THE CITY OF DAYTONA BEACH OFFICE OF THE PURCHASING AGENT

ADDENDUM NO. 2

PROJECT: ITB 19133
BETHUNE POINT AIR HANDLING UNIT REPLACEMENT

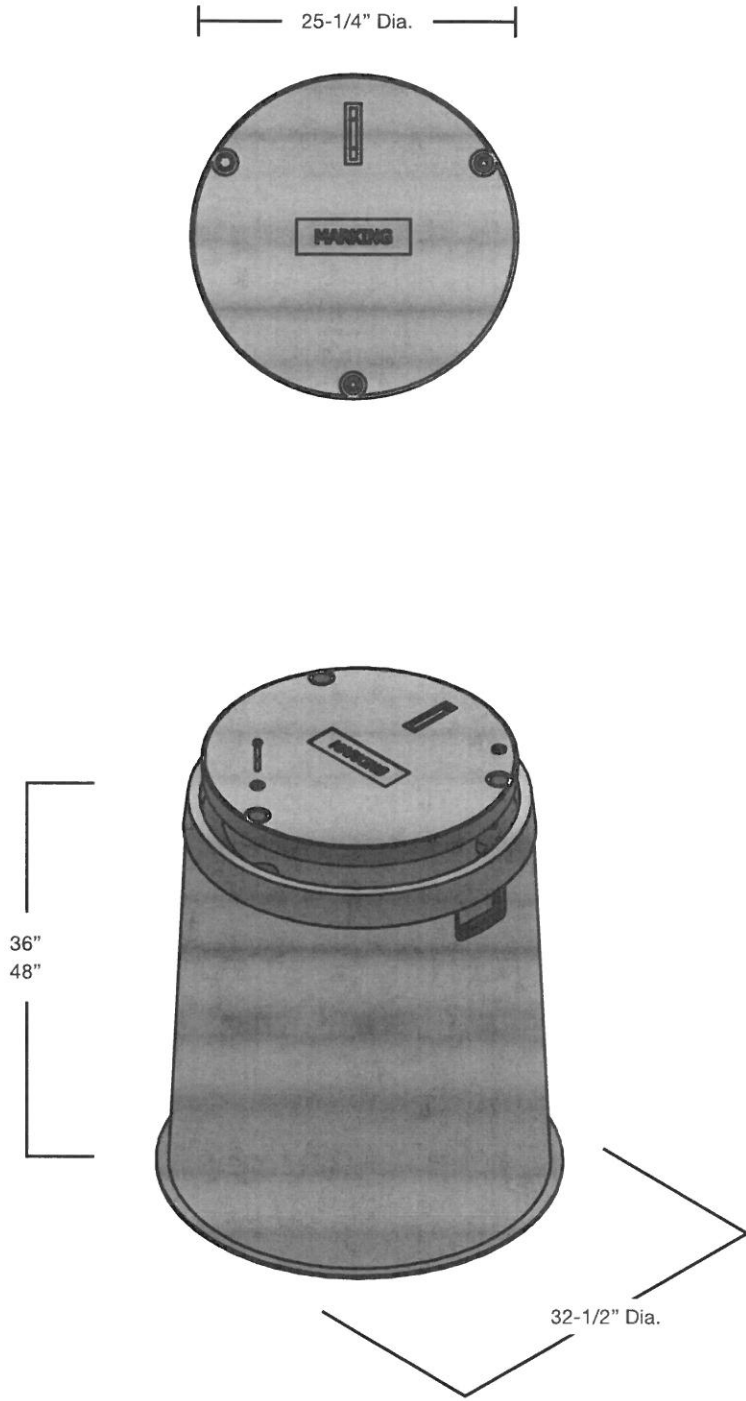
Q9: Is the drywell in the attachment acceptable

A9: Yes, the attached drywell (Oldcastle FRP 2700) meets the design intent.
